ADDENDUM NO. 2

Modify HVAC System

Missouri Supreme Court Building

PROJECT NO.: O2010-01

2 CONSTRUCTION STAGING PLAN
1" = 30'-0"

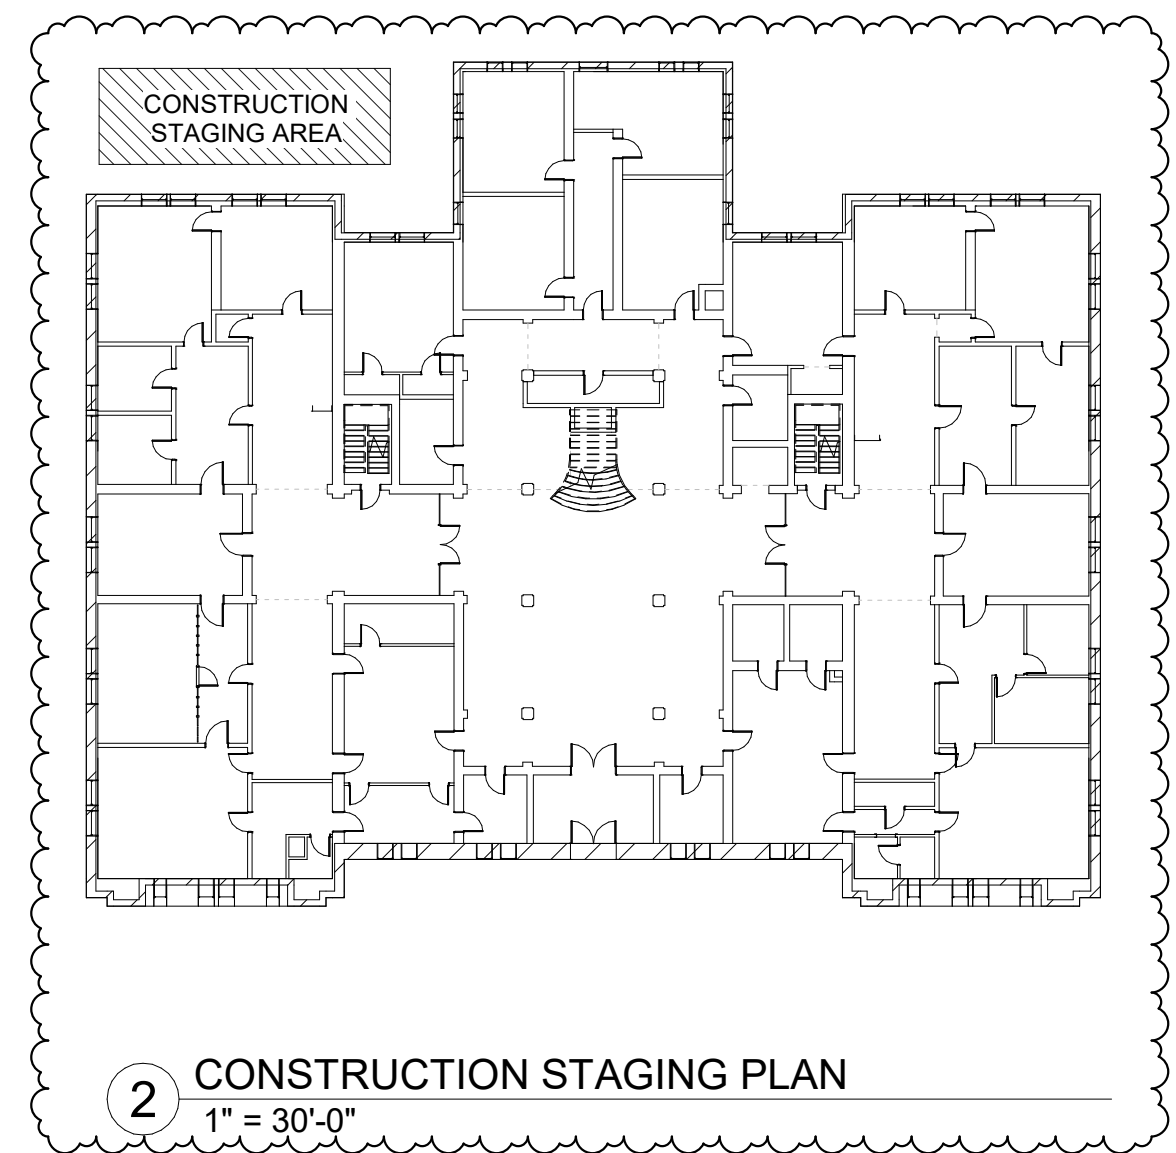
B. ADD Detail 2 showing the available construction staging area.

5 FAU-1 COOLING COIL COIL CONNECTION DETAIL
NTS

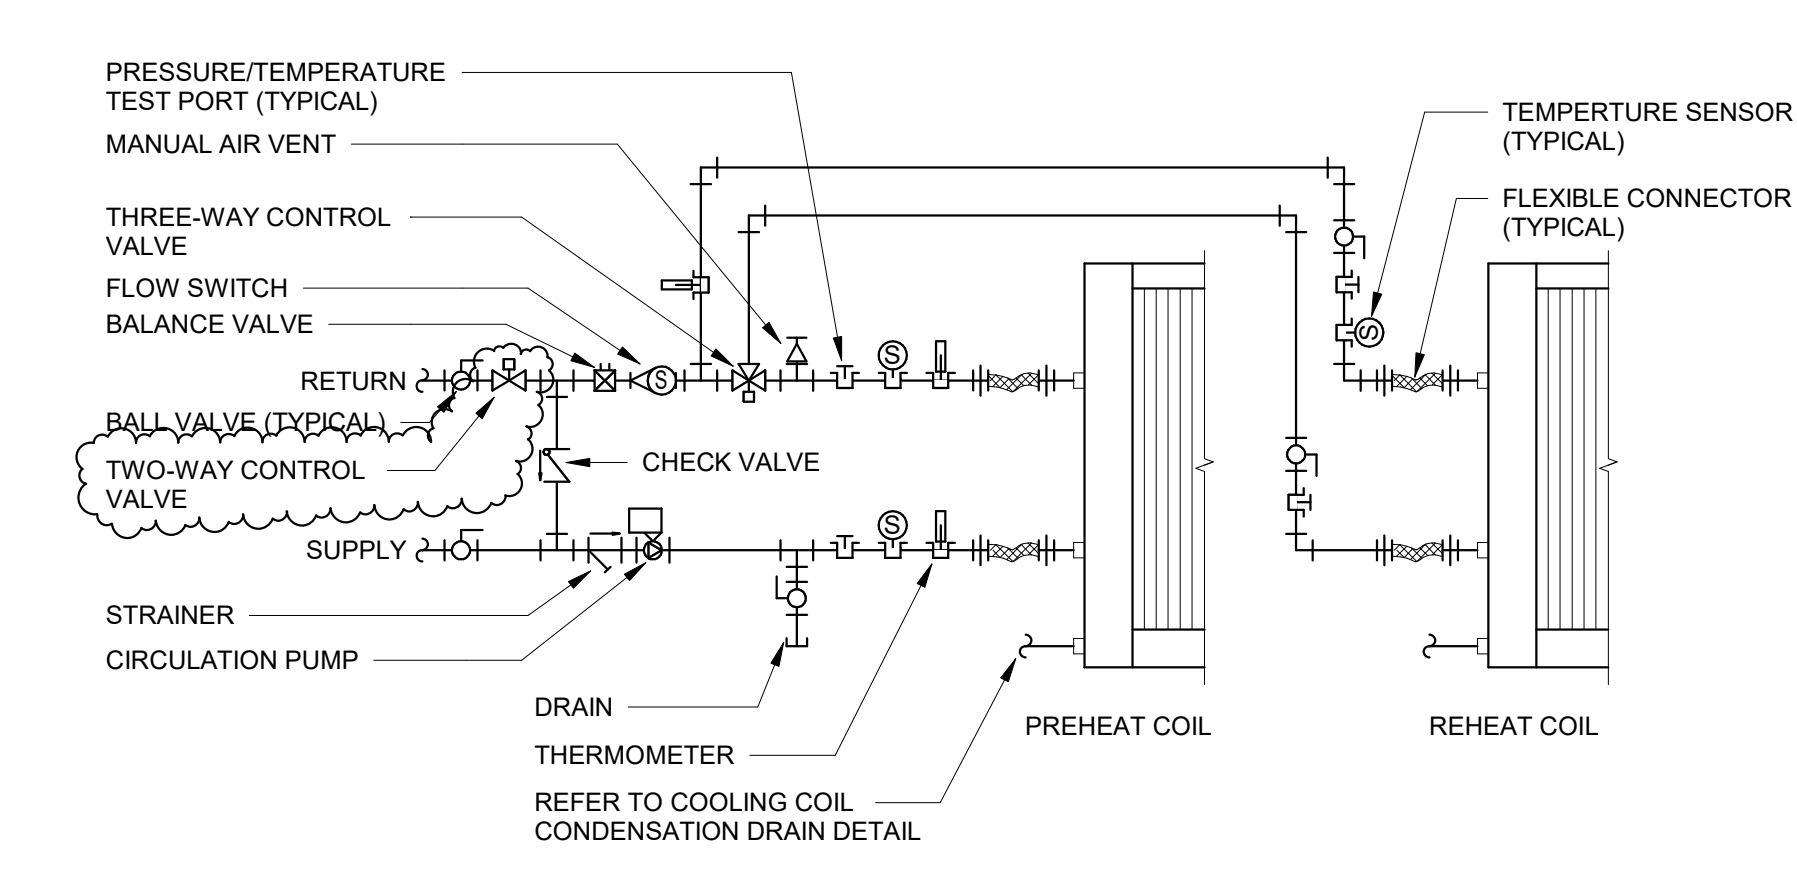
A. CHANGE Detail 5: Control valve shall be two-way. Move circulation pump to bypass. Add temperature sensors on chilled water supply and return piping to match Fresh Air Unit Controls Diagram.

6 FRESH AIR UNIT HEATING COIL CONNECTION DETAIL
NTS

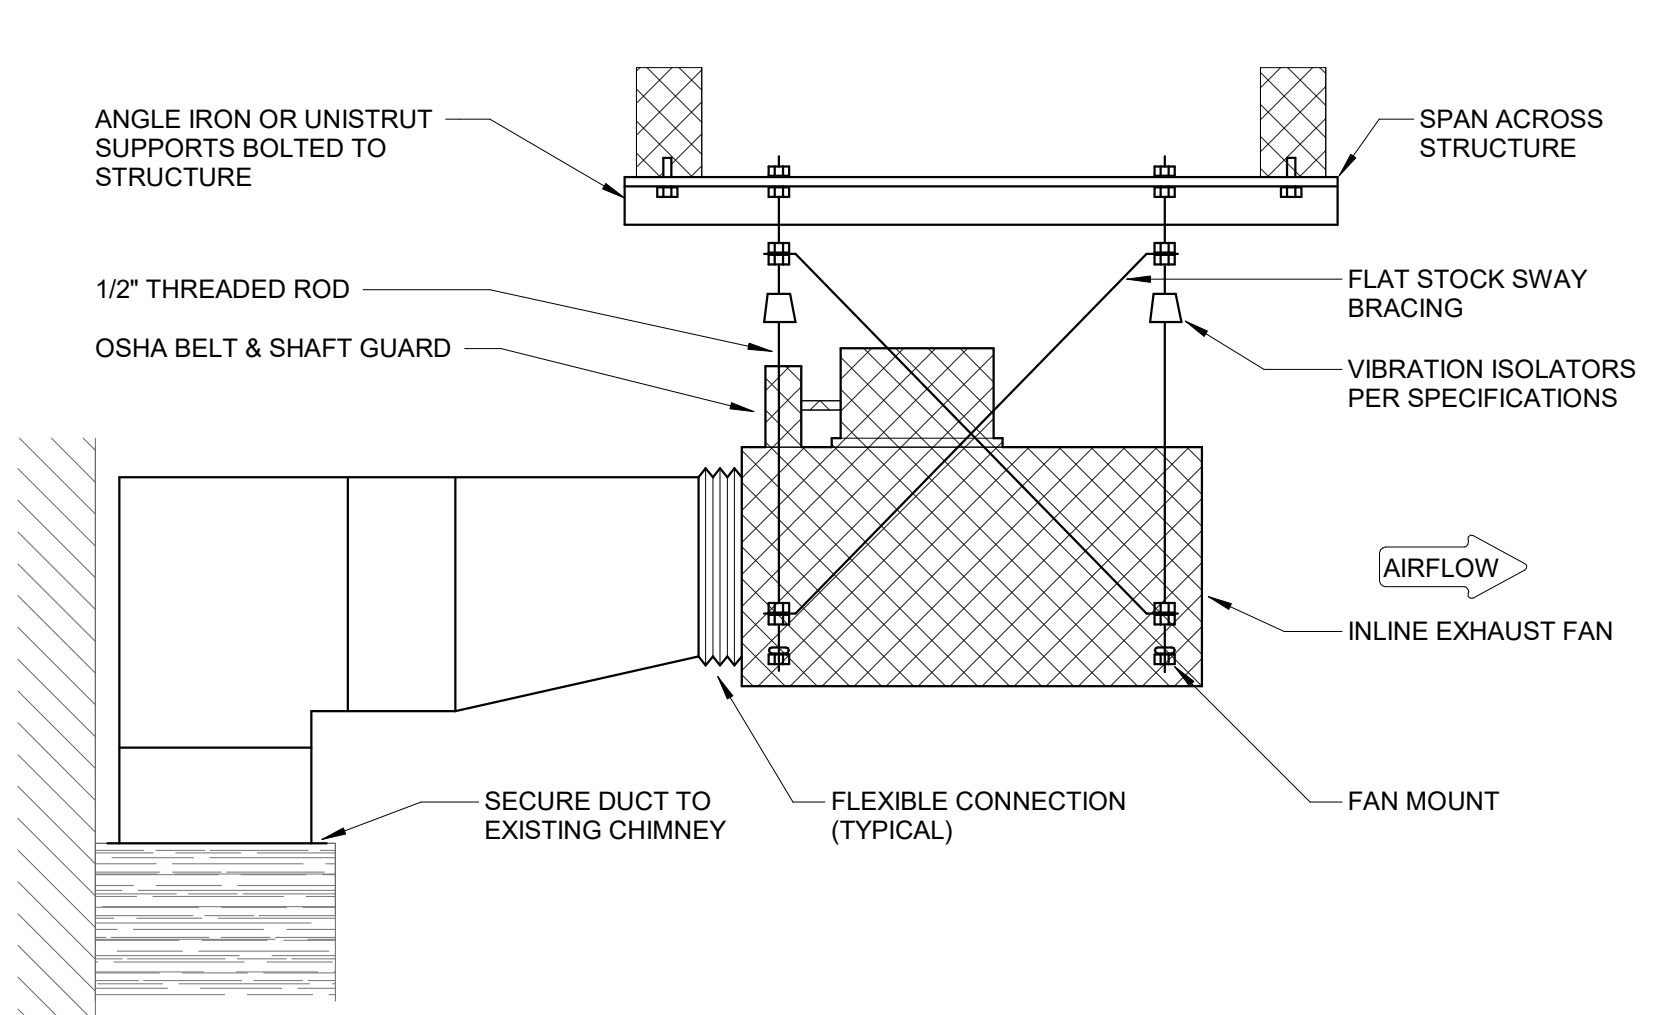
B. CHANGE Detail 6: Heating control valve shall be two-way.

1 HEATING COIL CONNECTION DETAIL
NTS

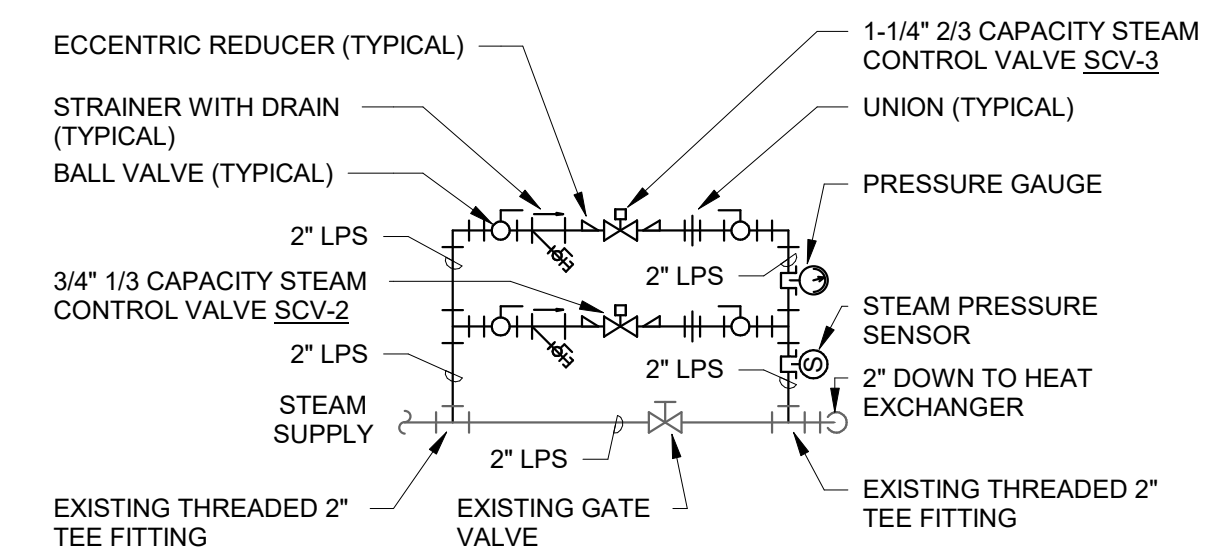
A. CHANGE Detail 1: Heating control valves shall be two-way.

2 FRESH AIR UNIT CONTROLS DIAGRAM
NTS

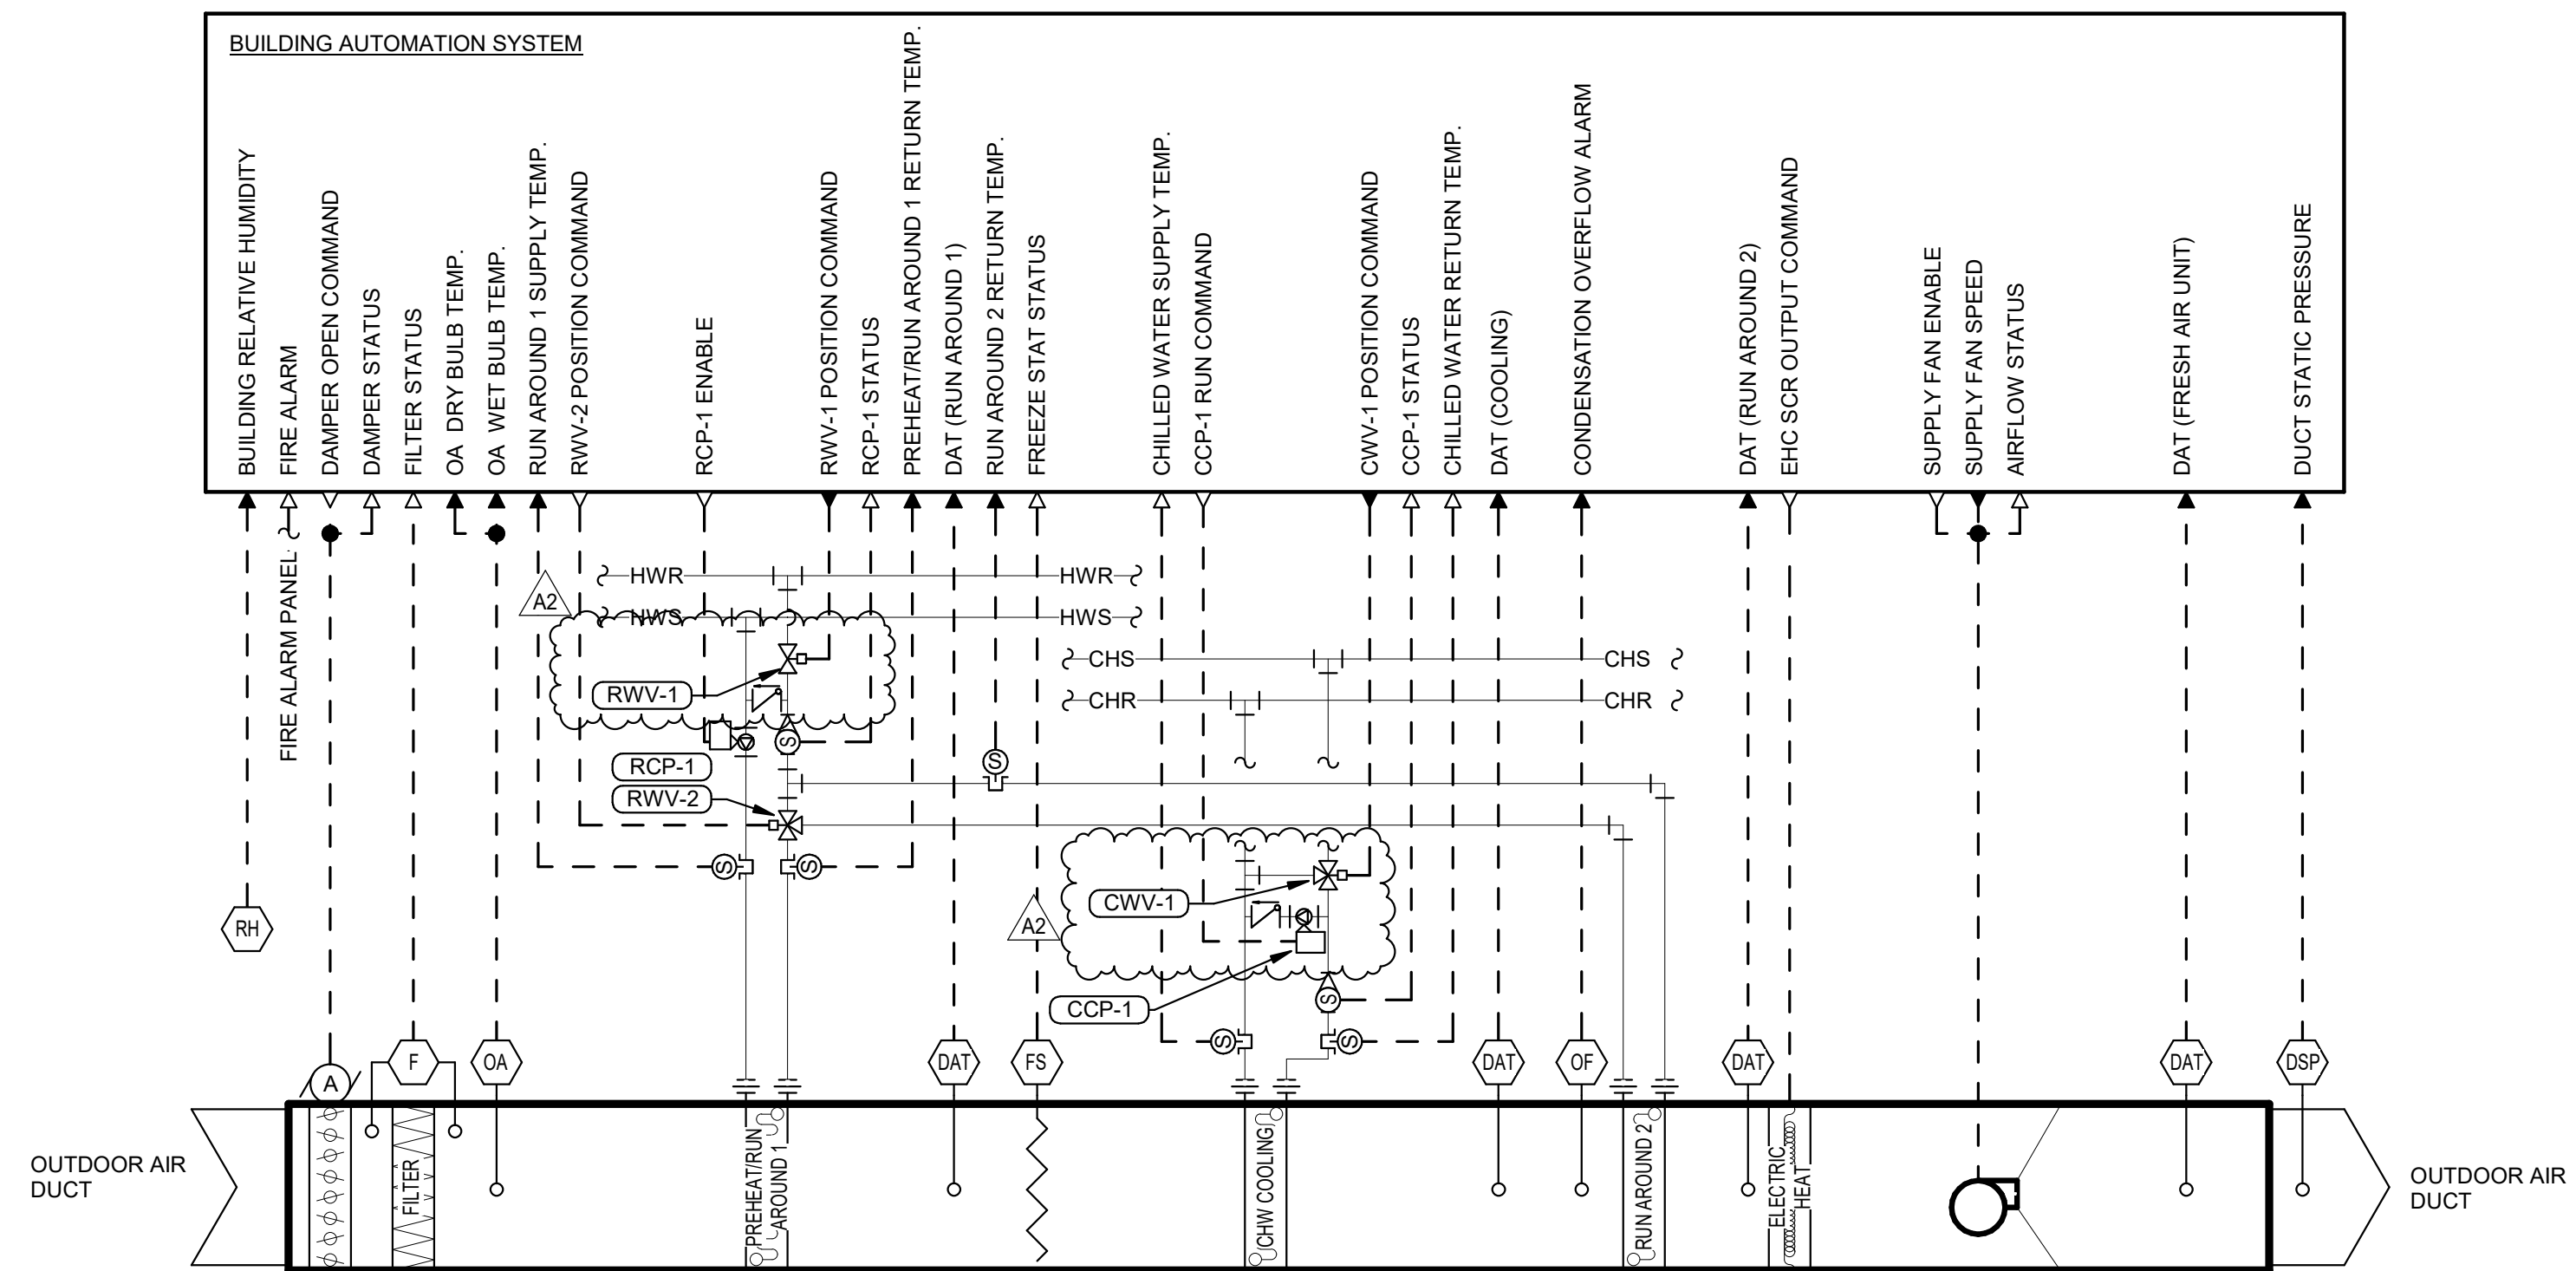
A. CHANGE Detail 2: Revise control valve and cooling coil circulation pump (CCP-1). Revise Run Around Coil control valve. Revise sequence of operations for the cooling coil circulation pump (CCP-1) and run around coil valve 1 (RWV-1).
